Additional Studies and Peer Reviews
prepared by Fehr & Peers and Rincon
Consultants for Planning Commission

Date: October 5, 2016
To: Joe Power, Rincon Consultants
From: Sarah Brandenberg, Fehr & Peers
Subject: **Supplemental Transportation Data following September 26 Planning Commission Meeting for One Beverly Hills**

LA15-2776

New Site Plan Proposed by Oasis West Realty

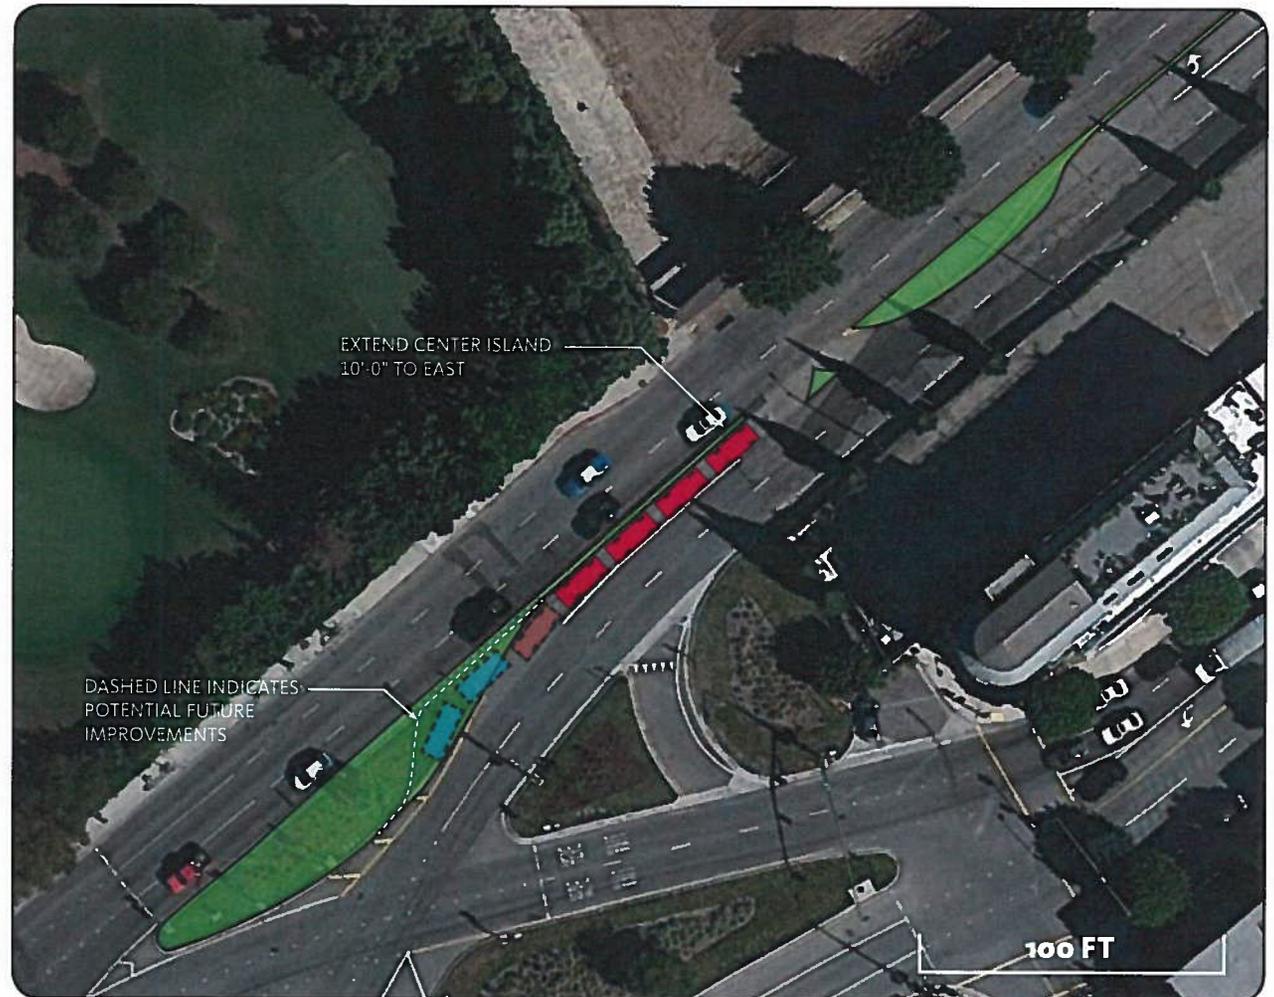
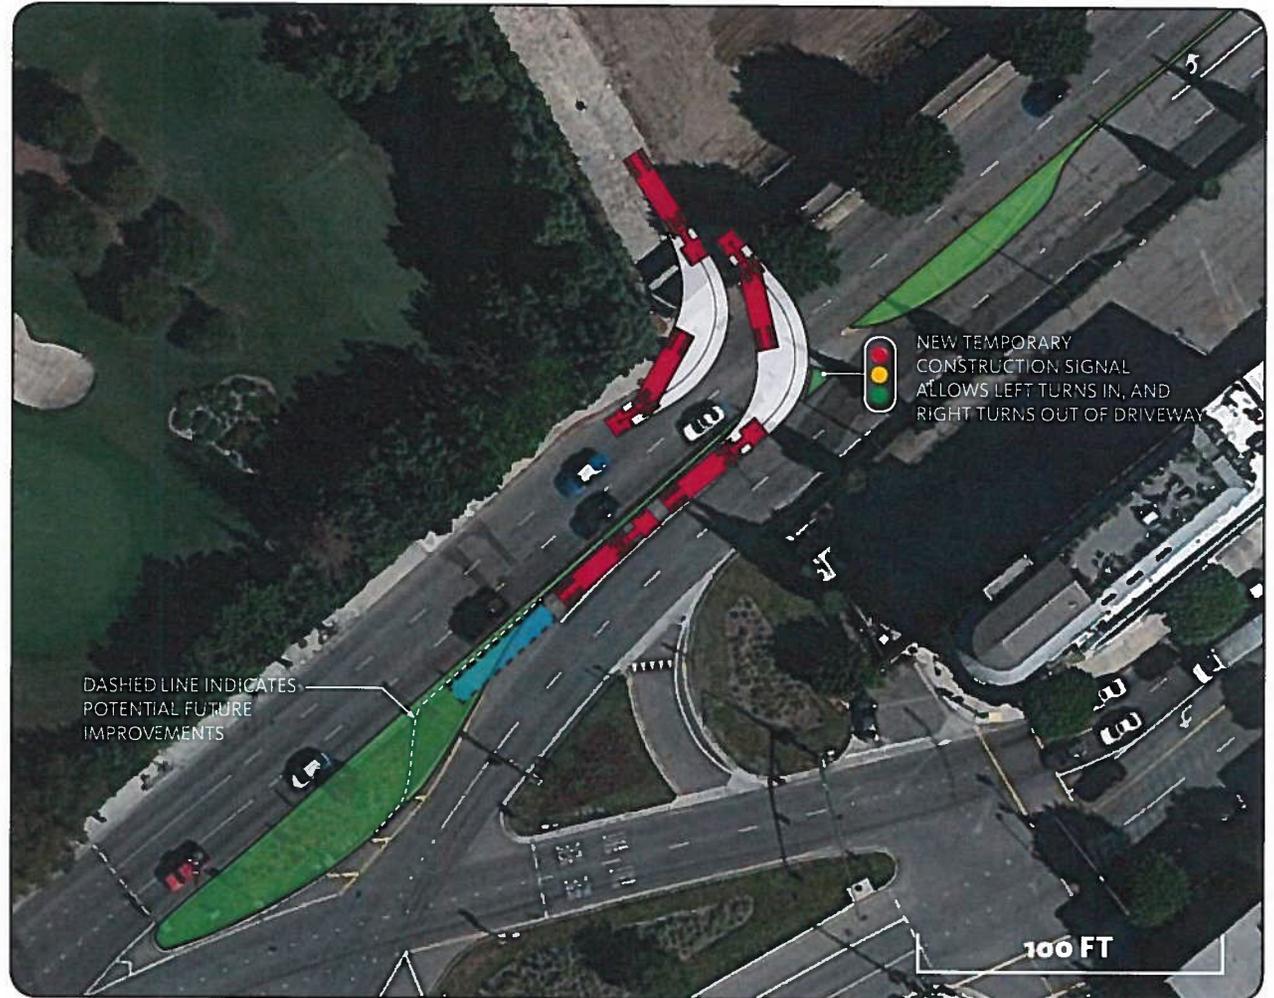
- The West Access Road & Santa Monica Boulevard intersection would not meet peak hour traffic volume warrants for the installation of a traffic signal¹. This is due to the number of vehicles utilizing the West Access Road during the peak hours (fewer than 100 vehicles per hour).

- The signalized intersection would be in very close proximity to the existing traffic signal at the Santa Monica Boulevard North & South Cross Over intersection located approximately 200 feet to the west and the planned traffic signal at Merv Griffin Way located approximately 400 feet to the east.

- The median placed between the existing left-turn pocket at the West Access Road and the adjacent left-turn pocket at Merv Griffin Way would reduce the amount of storage for vehicles turning from eastbound Santa Monica Boulevard onto Merv Griffin Way by approximately 100 feet.

- Without the installation of a traffic signal, vehicles could not exit the West Access Road to make a left turn onto eastbound Santa Monica Boulevard. Santa Monica Boulevard will be widened to three lanes in the westbound direction upon completion of the Project's and Beverly Hilton's mitigation measures. No other Project driveways, nor Beverly Hilton driveways, permit a left-turn movement across three lanes of adjacent street traffic.

- A temporary construction signal is not needed. During construction, a flagman would control truck turning movements in and out of the Project site. The flagman can stop vehicles for the minimum amount of time needed to allow a truck to turn in/out of the

Based on the discussion above, we do not recommend implementing the proposed new access scenario for the Hotel Motor Court. If the Planning Commission would prefer to restrict access to the Hotel Motor Court, the following modifications could be made to the Preferred Access Option:

- Remove left-turn access directly from eastbound Santa Monica Boulevard to the Hotel Motor Court (or restrict left-turn access during afternoon peak hours, 4:00 to 7:00 PM).
- Restrict outbound access during the morning peak hours (7:00 to 9:00 AM) from the Hotel Motor Court onto Merv Griffin Way and implement "Keep Clear" signage and pavement markings to minimize the potential of southbound vehicles traveling on Merv Griffin Way being blocked by vehicles exiting the Motor Court.
